UNIVERSITY 5031
5031 11th Avenue NE
Seattle, WA 98106

SDCI PROJECT #:
3036901-LU
3039694-EG

CITIZEN
DESIGN

EDG RESPONSE

FRONT SETBACK

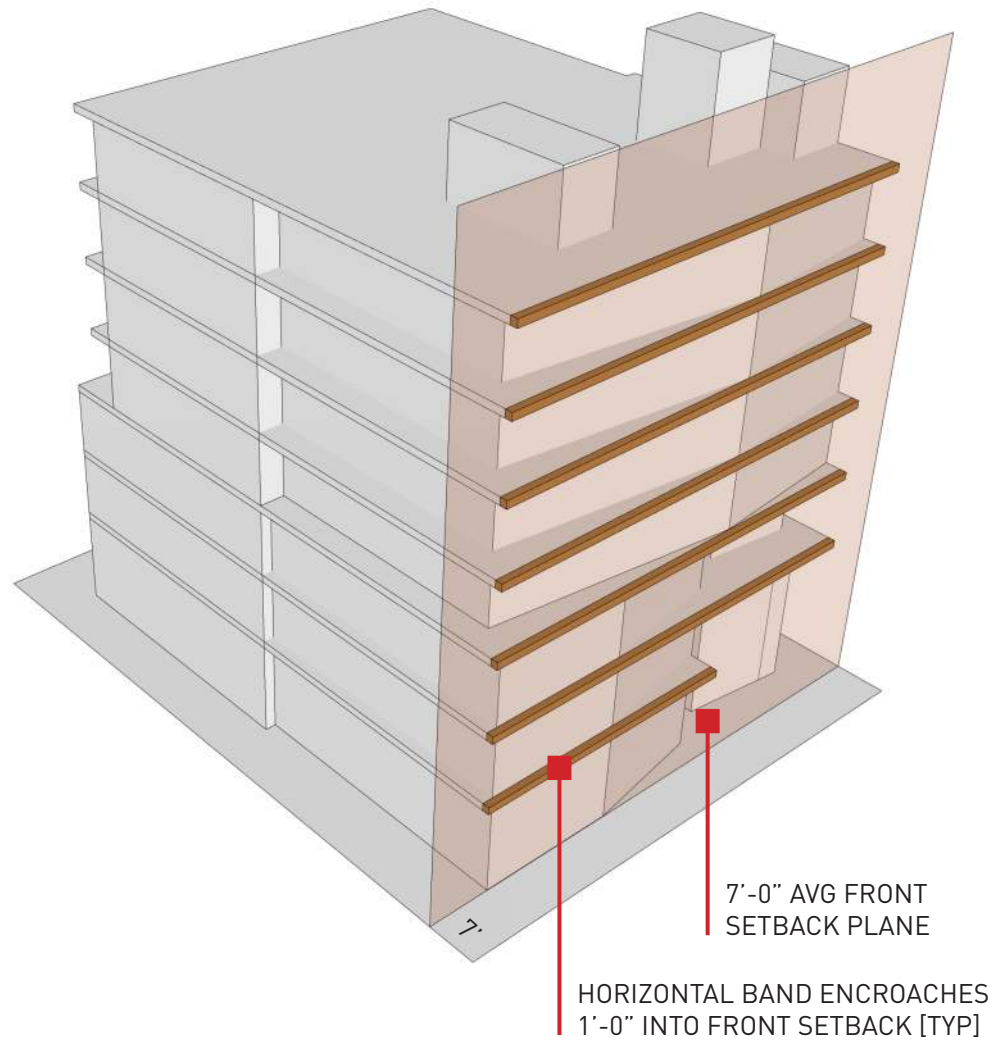
STANDARD	PROPOSED DEPARTURE	JUSTIFICATION
<p>FRONT SETBACK <i>(SMC 23.45.518)</i> Front: 7 ft Avg, 5 ft Min.</p>	<p>For portions of the building above 42 ft, reduce the average setback requirement from 7'-0" to 5'-9" [17.9% reduction]. Minimum setback requirement [5'-0"] to remain unchanged.</p> <p>Portions below 42 ft to comply with standard setbacks.</p>	<p>Granting this departure enables the provision of the long, horizontal bands on the front [east] façade of the building. These bands serve several functions. First, they visually divide the façade into a stack of horizontal elements rather than a monolithic, vertical element [DC2-A-2]. They also add depth and interest to the façade as suggested by DC2-C-1 and DC2-2-i. Finally, the bands serve as balconies in some locations, adding a human presence to the façade and helping connect it to the street [CS2-B-2].</p> <p>Note that the setback departure is required only because of the voluntary dedication of property to the 11th Avenue NE right-of-way. The building's location would be permitted without a front setback departure if this dedication were not made.</p>

As can be seen in the above diagram, this departure is associated with the horizontal bands on the east façade. Granting the departure will allow the bands to project forward from the overall mass of the building, contributing to the dynamic play of light and shadow in this option. This interplay can be seen on Pages 20-23. Allowing the bands to project forward also helps them read as separate entities from the overall massing, giving additional texture to the street-facing façade. As discussed on Page 18, this departure request is supported by design guidelines DC2 and CS2. It is also supported by EDG comments 2a and 2b.

The proposed structure itself complies with the setback requirement. Only the horizontal banding is affected by this departure request.

NORTH SIDE SETBACK

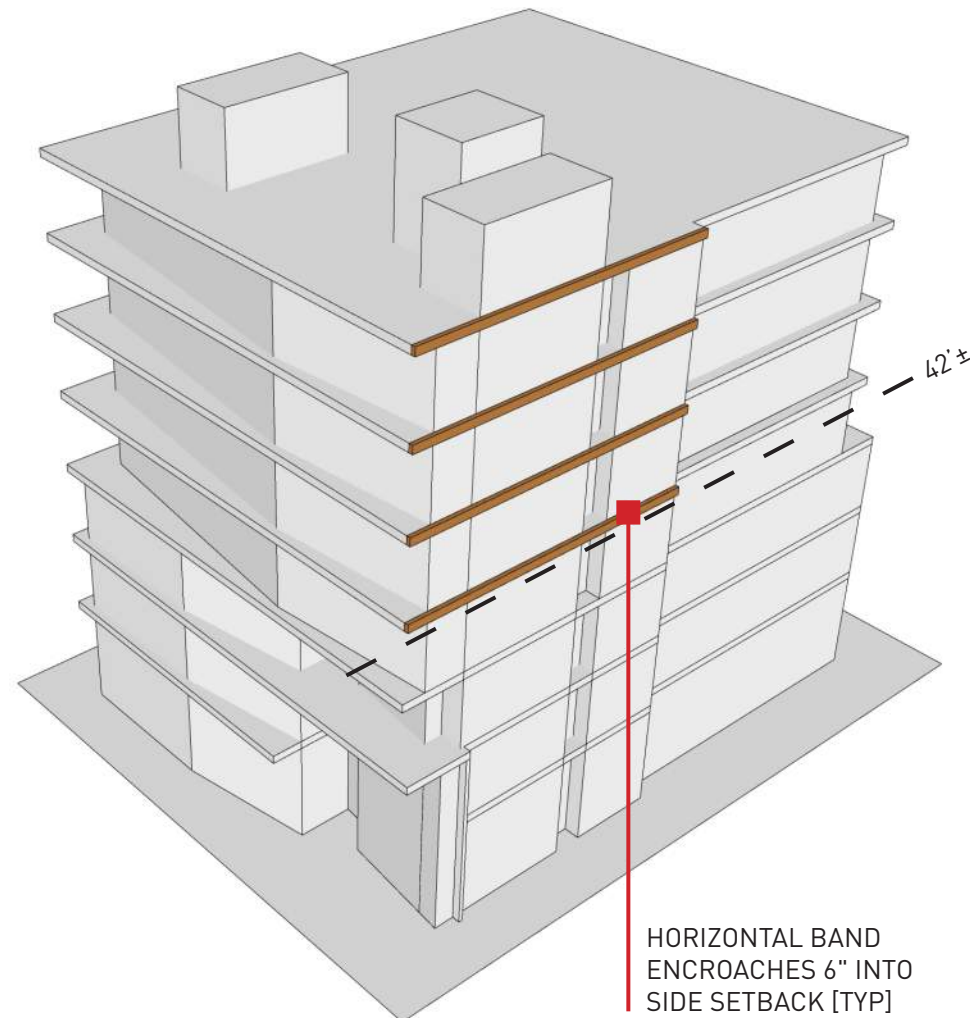
<p>NORTH SIDE SETBACK <i>(SMC 23.45.518)</i> Below 42 ft: 7 ft Avg, 5 ft Min. Above 42 ft: 10 ft Avg, 7 ft Min.</p>	<p>For portions of the building above 42 ft, reduce the average setback requirement from 10'-0" to 9'-8½" [2.9% reduction]. Minimum setback requirement [7'-0"] to remain unchanged.</p> <p>Portions below 42 ft to comply with standard setbacks.</p>	<p>Granting this departure permits the horizontal bands to wrap the northeast corner of the building and extend along the north side façade. This helps tie the front and side façades together and contributes to the quality of the side façade [DC2-B-1]. Wrapping the bands around the corner also allows them to be viewed from multiple angles, creating a dynamic interplay for passersby [DC2-C-1].</p>
<p>SOUTH SIDE SETBACK <i>(SMC 23.45.518)</i> Below 42 ft: 7 ft Avg, 5 ft Min. Above 42 ft: 10 ft Avg, 7 ft Min.</p>	<p>For portions of the building above 42 ft, reduce the average setback requirement from 10'-0" to 9'-10½" [1.3% reduction]. Minimum setback requirement [7'-0"] to remain unchanged.</p> <p>Portions below 42 ft to comply with standard setbacks.</p>	<p>Granting this departure has two primary effects. As with the north side setback departure [above], this departure allows the horizontal bands to wrap the southeast corner. This improves the quality of the south façade, visually ties the east and south façades together and results in a more dynamic design [DC2-B-1, DC2-C-1]. Additionally, this departure allows the bands to be occupied as balconies near the southeast corner of the building. This adds a human presence to the corner and helps connect it to the public realm below [CS2-B-2].</p>

Granting this departure request allows the horizontal bands on the front of the structure to wrap around the northeast corner as requested in EDG comment 2b. Without the departure, the bands would need to be in plane with the rest of the façade. Allowing the bands to project adds detail and texture to the façade as supported by design guidelines DC2 and CS2.

The proposed structure can comply with the standard setback requirement. The function of this departure request is to allow the banding.

SOUTH SIDE SETBACK

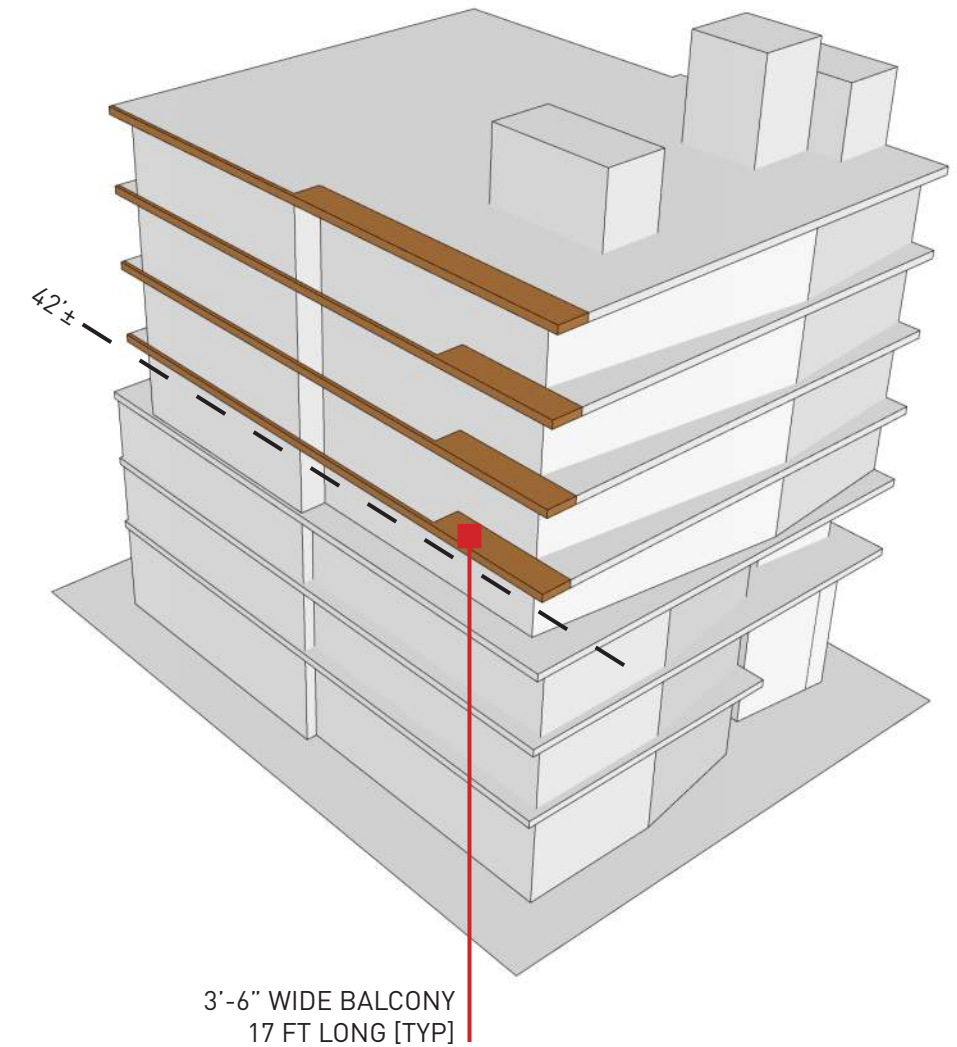
b. Staff recommends wrapping the horizontal banding on all façades for a consistent overall architectural expression, particularly at the northeast corner. Attention to materiality and detail will be critical to the successful expression of a seamless wrapped band. Maintain a plane change between the horizontal band and the adjacent façade. Staff specifically prioritizes University District Design Guidelines DC2-2-h, Detailing, and DC2-2-i, Depth. Provide dimensioned details in the Recommendation packet. [DC2-2-h, DC2-2-i]

c. Staff strongly supports the intent to provide both recessed and projecting balconies that are well-integrated with the horizontal banding expression, as depicted in the precedent images on page 38 of the EDG packet. In agreement with public comment, balconies should be designed and adequately sized to function as a usable amenity. Staff specifically prioritizes citywide Design Guideline DC2-C-1, Visual Depth and Interest, and DC2-C-2, Dual Purpose Elements. [DC2-C-1, DC2-C-2]

Granting this departure request allows the horizontal bands on the front of the structure to wrap around the south side. Without the departure, the shaded areas in the above diagram would need to be removed from the design. This would result in the east-facing bands terminating at the exterior wall of the structure rather than following the line of the floor below. This will look incomplete. It will also result in a loss of texture, detail and human occupancy at that corner. EDG comments 2a, 2b and 2c support granting the departure to allow these balconies.
